Access Compliance Report Public Rights-of-Way (Curb Ramps)

Main Street: CRAWFORD_CANYON_RD		Cross Street: CRAWFORD_CANYON_RD		Location:	SW
ADA ID: RPAT220225154859	Ramp Type: Type 6 - Directional 1	Initial Pass/Fail: Pass	Overall Compliance: No	Severity Score:	6

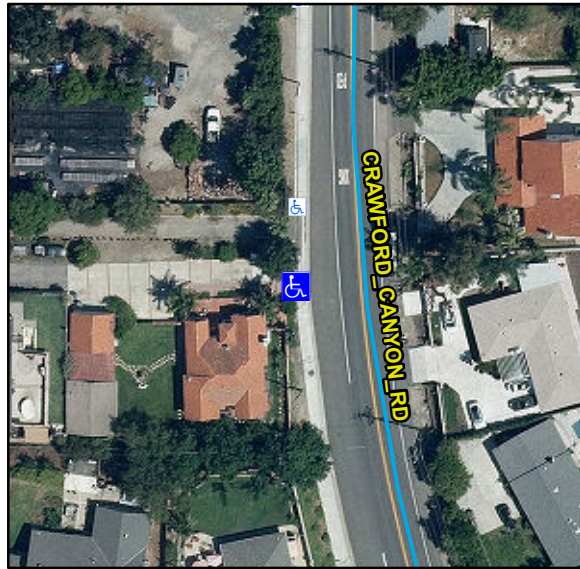
R304.5.3, R305.1.4, STD 1115

Compliance	Description	Data	Compliance	Description	Data
N/A	Ramp Length (in)	120	N/A	Flare Type LT	
Yes	Ramp Width (in)	64			Sloped
Yes	Ramp Run Slope (%)	6.1	Yes	Flare Slope LT (%)	4.7
Yes	Ramp Cross Slope (%)	2	N/A	Flare Traversable LT	Yes
Yes	Grade Break	Yes	Yes	Flare Type RT	
Yes	Grade Break Slope (%)	0.3			Curbed2
No	Grade Break Cross Slope (%)	2.8	N/A	Flare Slope RT (%)	N/A
	Addl Para Ramp Left?	No	N/A	Flare Traversable RT	N/A
	Addl Para Ramp Right?	No	Yes	DWS Provided	Yes
N/A	Landing Present	Yes	Yes	DWS Contrast	Yes
Yes	Landing Length (in)	60	Yes	DWS Length (in)	36
Yes	Landing Width (in)	66	No	DWS Full Width	No
Yes	Landing Run Slope (%)	0.5		DWS Offset Type	Multiple
No	Landing Cross Slope (%)	2.1	Yes	DWS Left Offset (in)	0
N/A	Landing Movement Obstructed?	No	Yes	DWS Right Offset (in)	29
	Landing Movement Type	N/A			
N/A	Landing Shared	Yes			
N/A	Marked Crosswalk 1	No	N/A	Clear Space	N/A
	Crossing 1 Direction	N	N/A	Clear Space To Crosswalk (in)	N/A

Remove & Replace Entire Ramp.
